# ARAPAHO ROAD - PHASE III

FROM SURVEYOR BOULEVARD TO ADDISON ROAD

PROJECT RECORD COPY I

Design    Drawn    DATE    SCALE    PROJECT NO.    SHEET NO.  
Check    Check    05-07-04    25768    BR-4

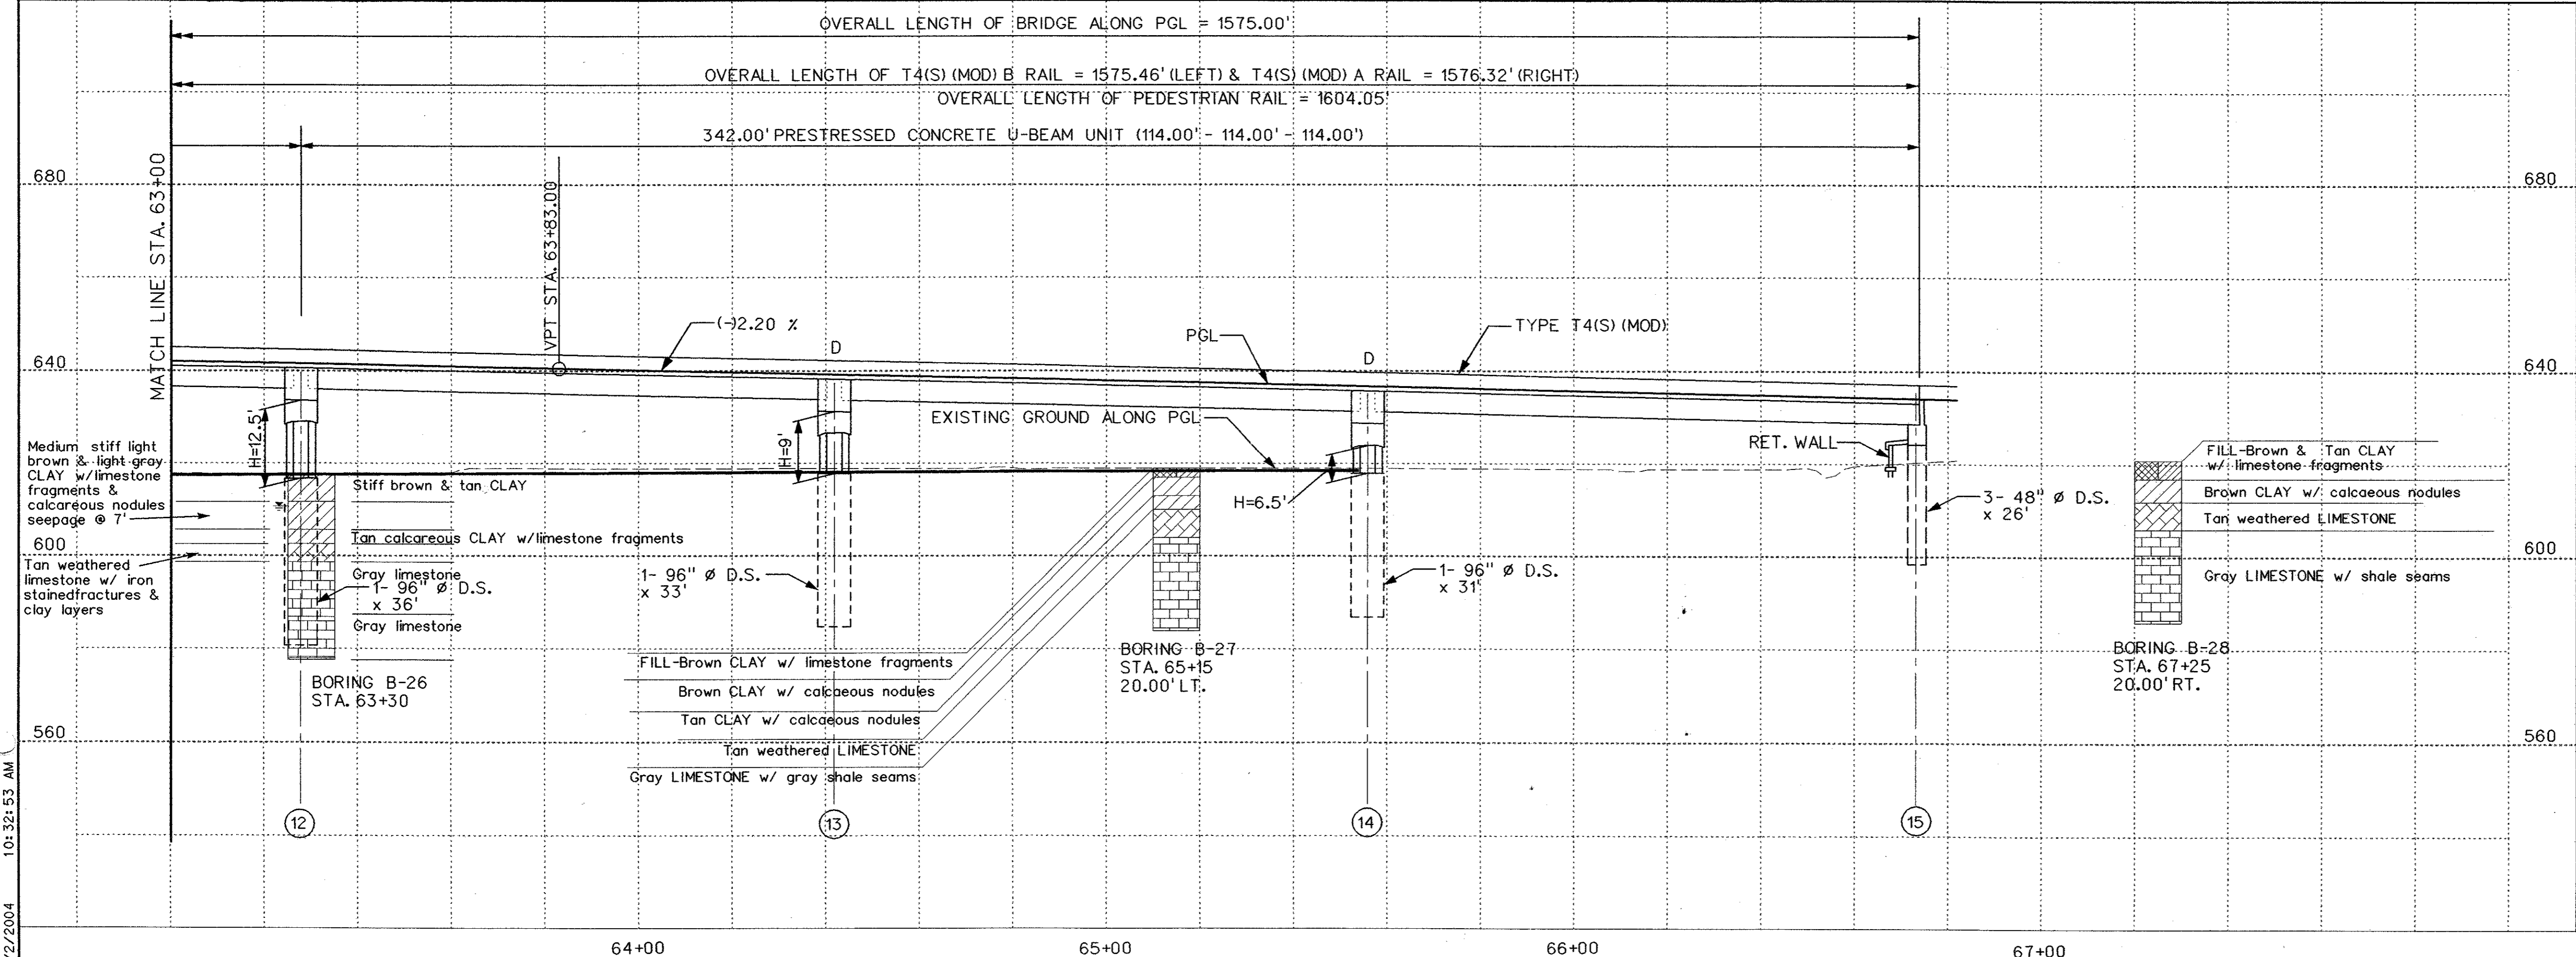
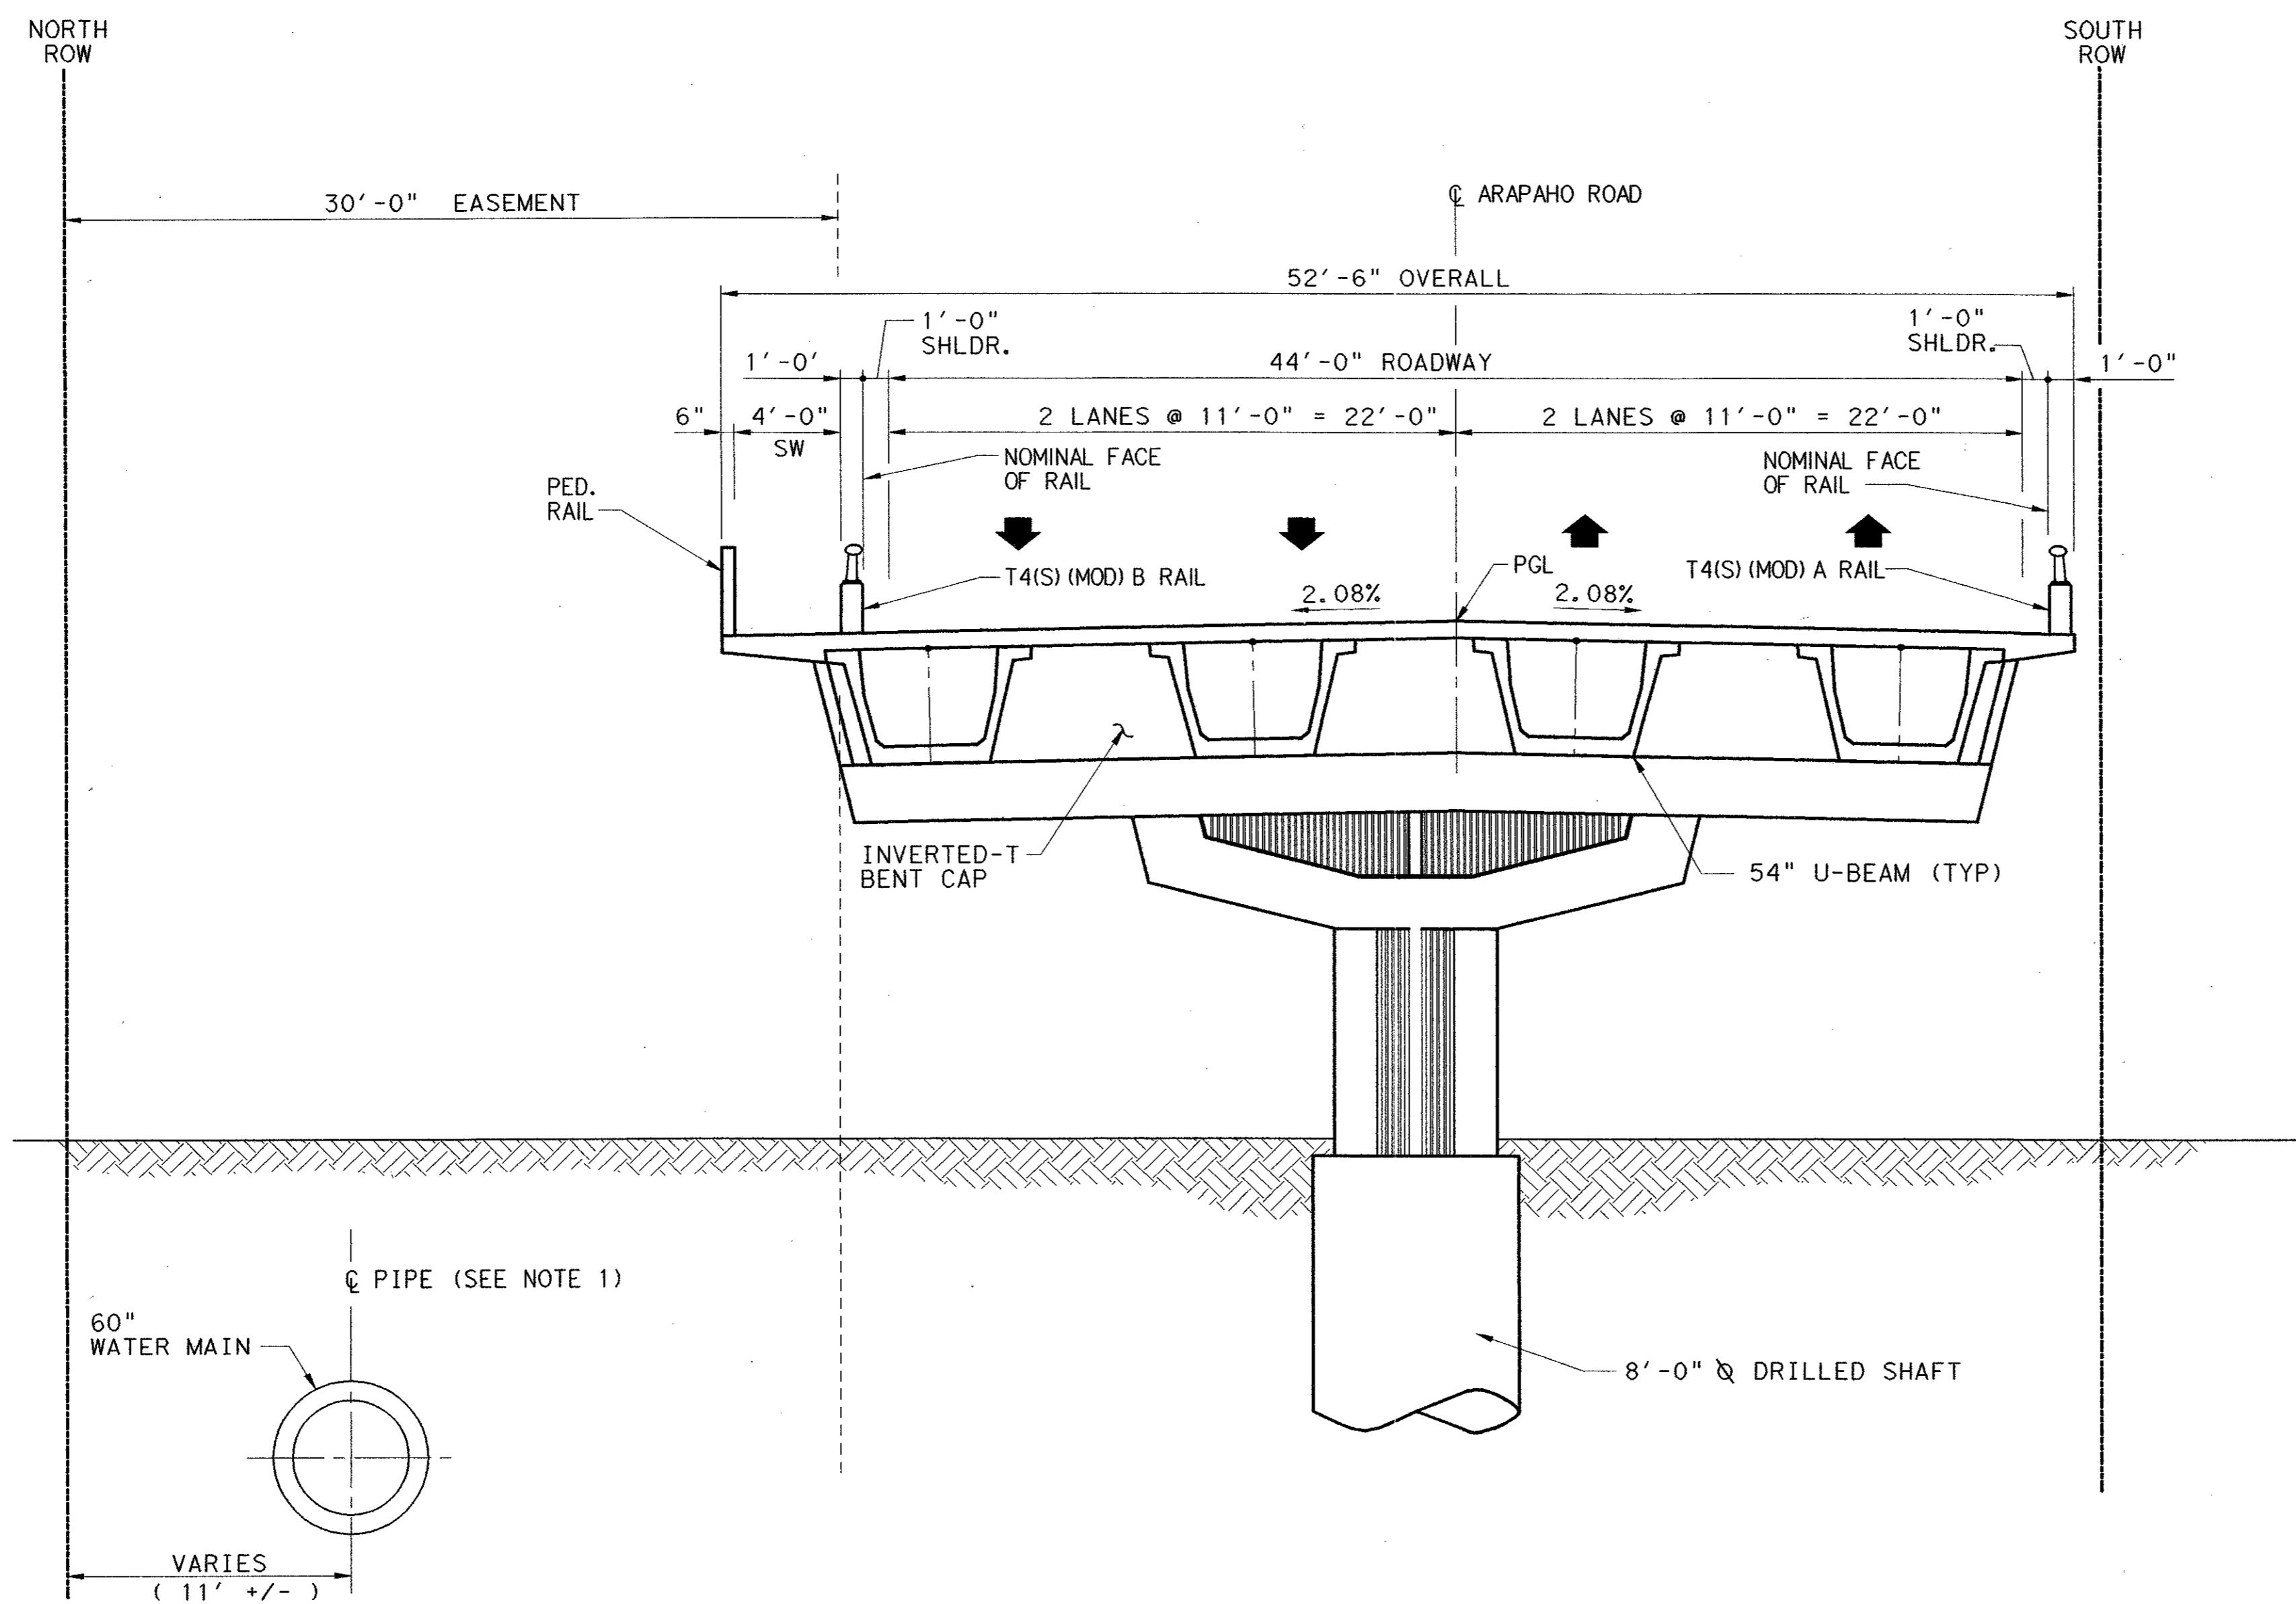
See RFI # 085  
Bridge Approach Slab Details.
